ADDENDUM #1

Date: April 17, 2025

Project: Tierney Park Improvements Project

Owner: Village of Lexington, Michigan

DT-ASPHALT TYP

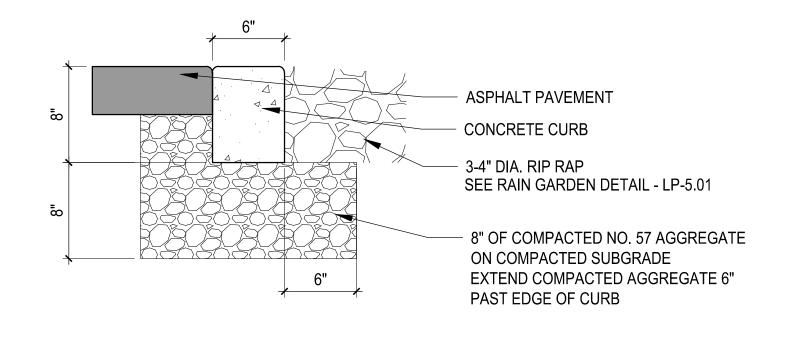
- 5. LS-5.01 Site Plan Details
 - a. Asphalt mix clarified
- 6. **LS-5.02** Site Plan Details
 - a. Allowable walkway cross-slope note added
- 7. LS-5.04 Site Plan Details

- 16. Q: Detail 6 on sheet LS-5.01 shows HMA 36A and HMA 13A, however the bid form shows 5E and 3E (would it be 3E1/5E1, 3EL/5EL or 3EML/5EML). Can you clarify which mix is to be used along with the preferred asphalt binder?

- A: Detail will be revised to match bid form. 3EL/5EL is the correct mix.
- 17. Q: Please clarify paint color for parking lot striping.
 - A: Striping to be white paint, typical, with Handicap Parking striping to be blue.

BOARDWALK PLAN

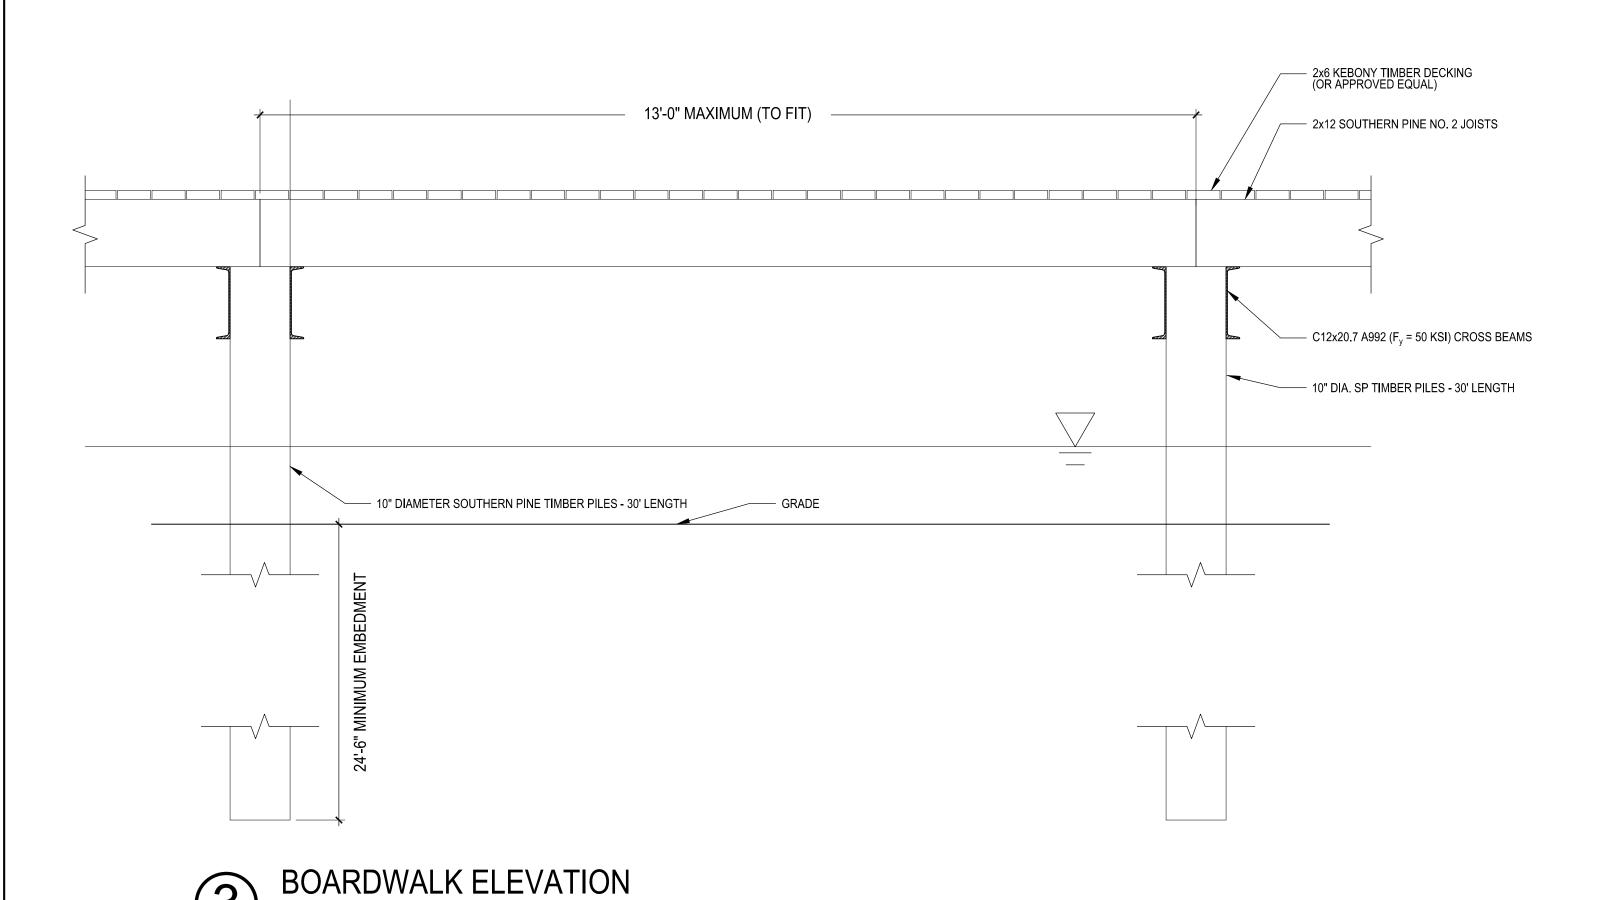
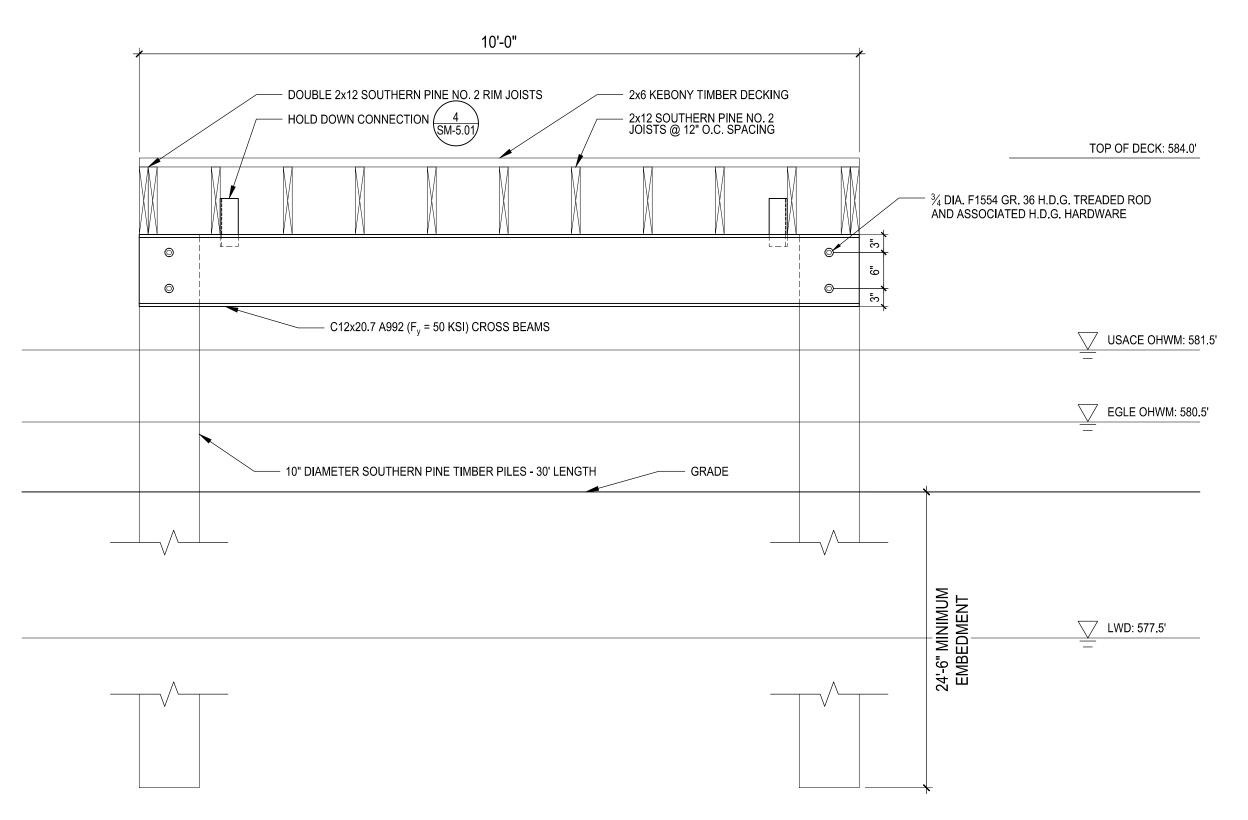
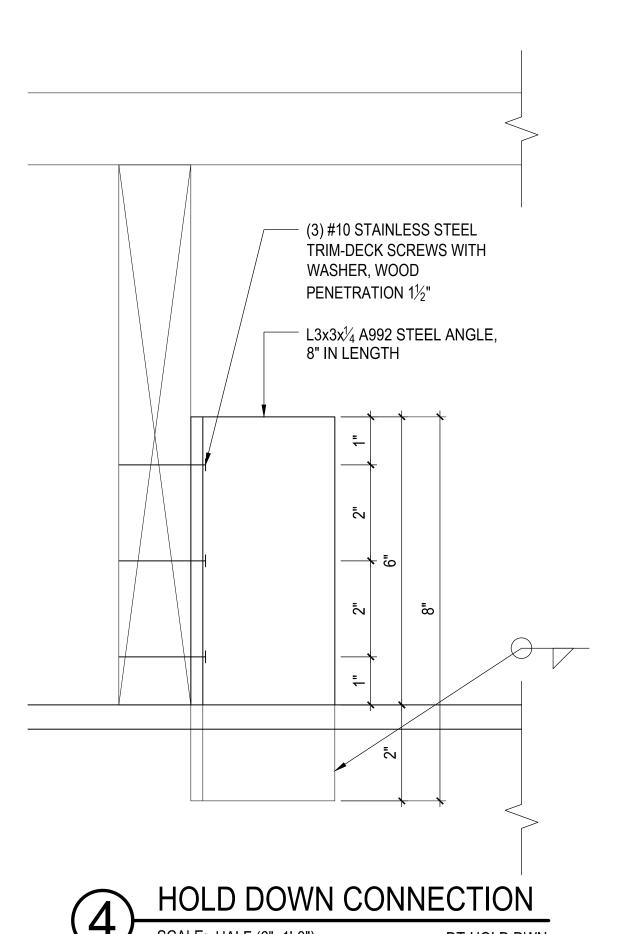
- a. Revised to show boardwalk plan view. Structural details moved, see New Drawings.
- 8. **E1.1** Electrical Plan
 - a. Conduit added to parking areas for potential future parking lot gates (gates NIC)

- 2. Q: Sheet LS-5.04 shows the timber piles 30' in length (boardwalk section and elevation) and 10' in length (boardwalk plan). Provide clarification on timber pile length.

- A: See new Sheets SM-5.01, 5.02, 5.03 for clarification.
- 4. Q: What should be assumed for the estimated pier length for boardwalk?
 - A: See modification on Sheet LS-5.04 for clarification.

BOARDWALK-EXISTING SEAWALL ATTACHMENT PLAN SCALE: 3/4"=1'-0" DT-BOARDWALK PLAN

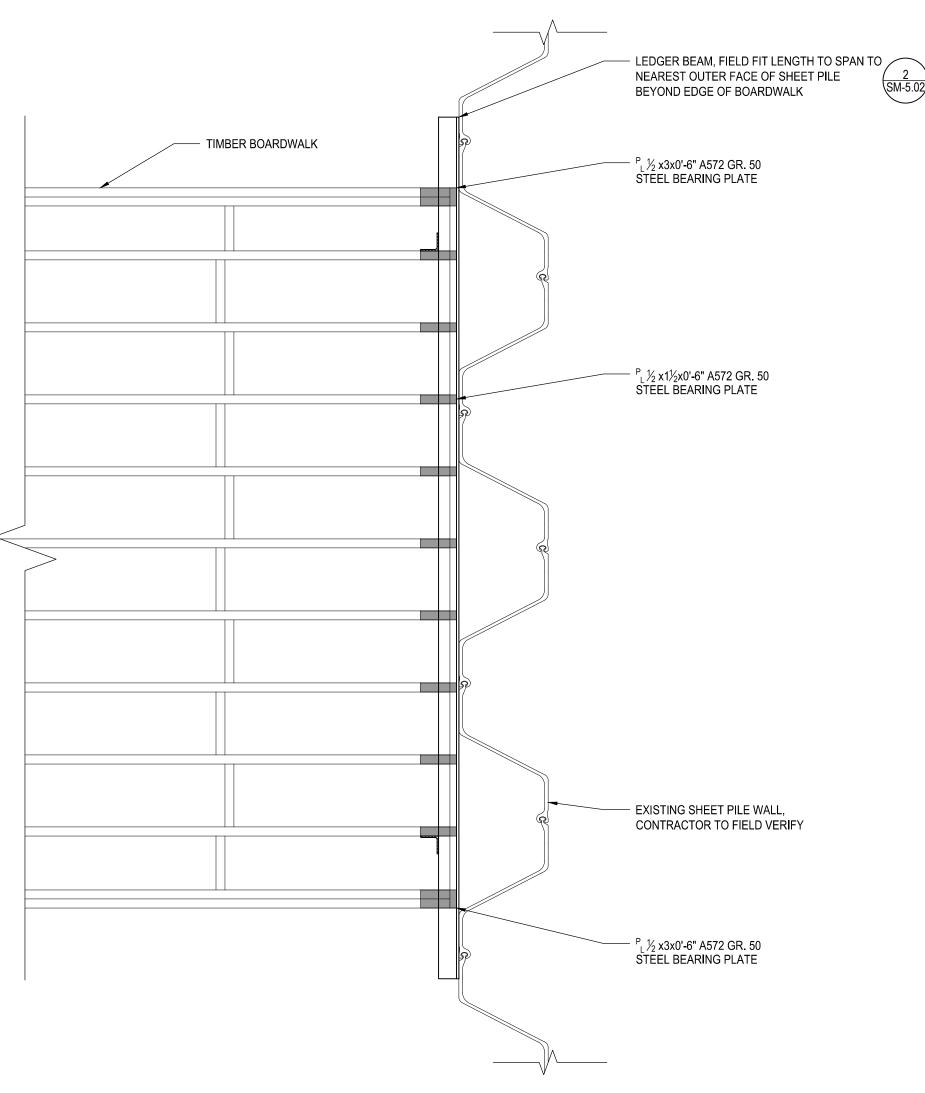
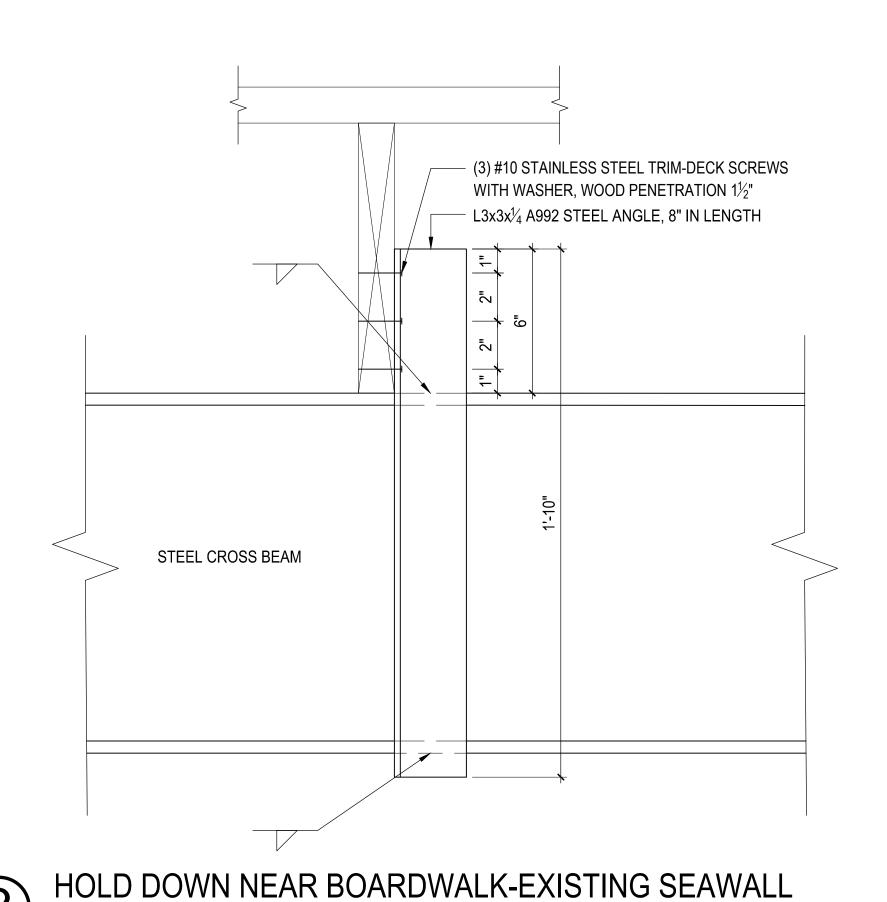
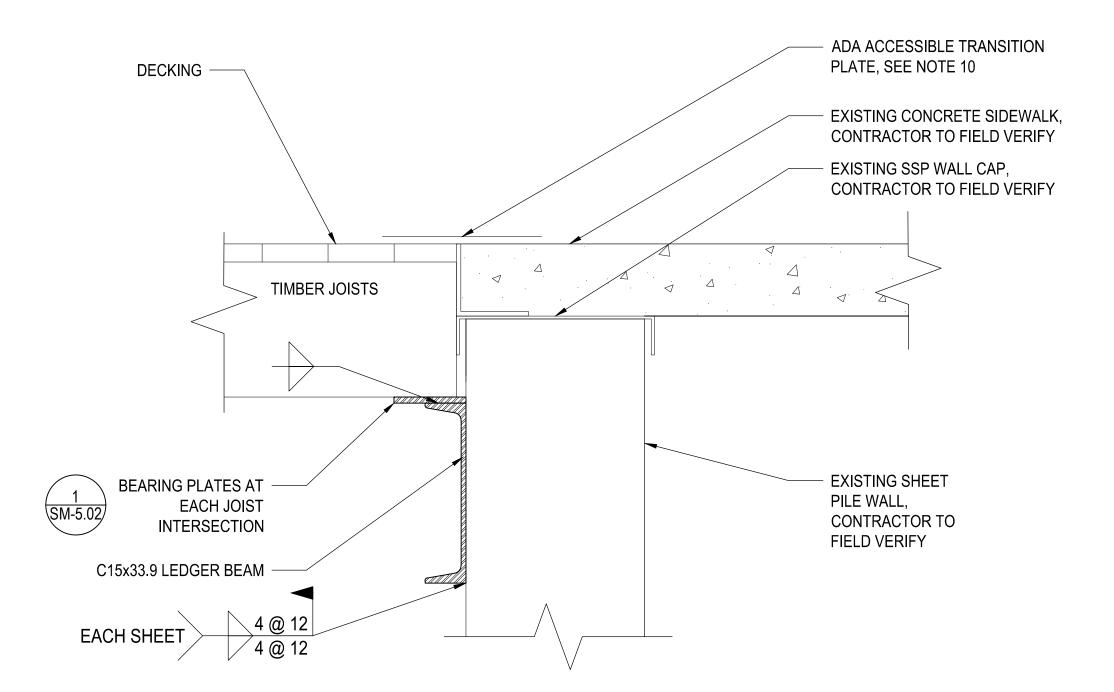
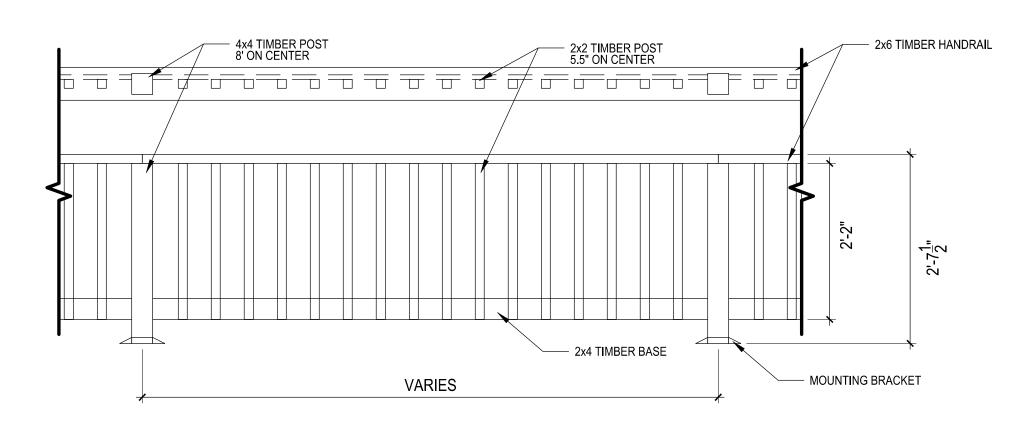
- 1. SM-5.01, SM-5.02, SM-5.03 Structural Marine Details
 - a. Boardwalk structural details moved to these sheets and information added
